Field Service Bulletin Trucks

Clutch Cable, Air Assist CHU, CXU, GU

FSB 413-001, Clutch Cable, Air Assist

(June 2013)

W4082280

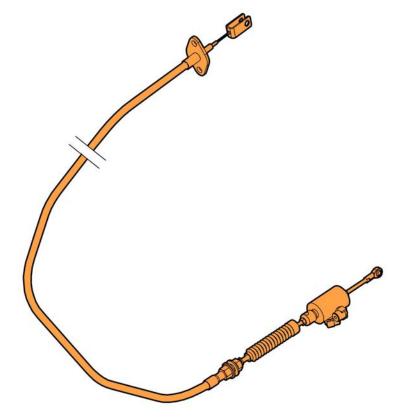
Some Mack conventional cab trucks equipped with air assisted clutch cable part number 21088848 may experience fraying of the clutch cable at the clevis where it attaches to the clutch pedal linkage. A new clutch cable (part number 22175475) was designed to increase durability of the clutch cable and to prevent cable fraying at the clevis.

Clutch Cable Control Assembly				
Item	Description	Part Number	Qty	
1	Clutch Cable Control Assembly	22175475	1
